Regular Public Meeting of the Englewood Cliffs  
Planning Board Minutes  
November 13, 2025

Application #345K - Commercial Site Plan Approval  
Englewood Hospitality, LLC – 495 Sylvan – Block 512 Lot 3

Engineering Review #2  
Englewood Hospitality, LLC (Applicant)  
Address (Block 512, Lot 3)  
Application #345K: Preliminary and Final Site Plan  
Colliers Engineering & Design Project No. ECP-0165

**Planning Review #2**

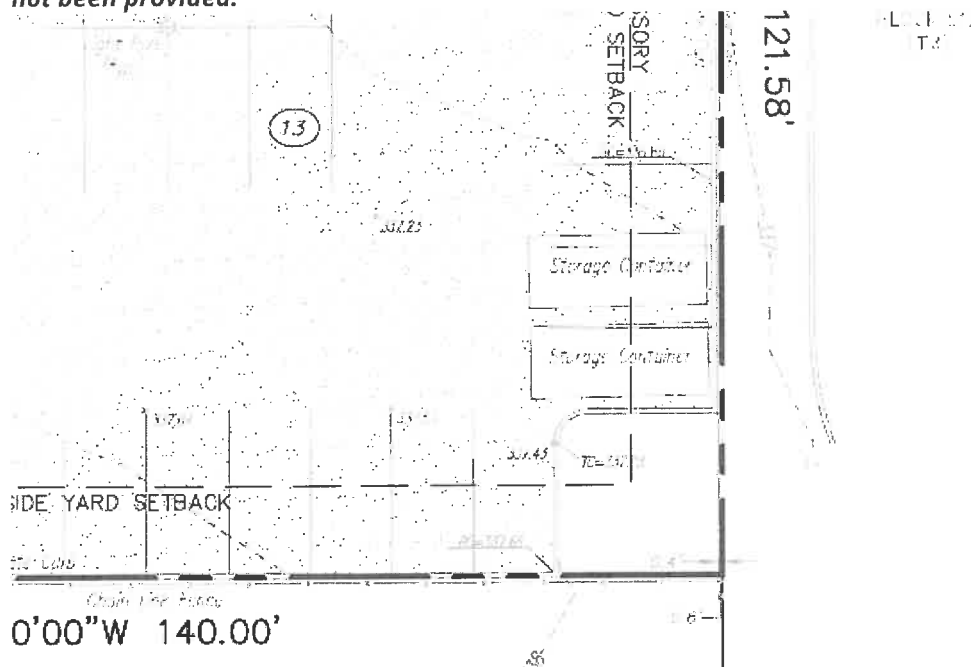
1. The Applicant's professionals must provide testimony that the proposed development meets each of the conditional use criteria, or otherwise does not exacerbate any existing nonconforming conditions which would require additional 'd(3)' conditional use variance relief. ***The Planning Review memo submitted by the Applicant acknowledges that conditional use variance relief is required for the front and side yard setbacks of the proposed prefabricated structure. Based on the information provided in the most recent submission, and from the July 2025 hearing, it also appears that the Applicant has***

***exacerbated a preexisting nonconforming condition concerning the number of required parking spaces.***
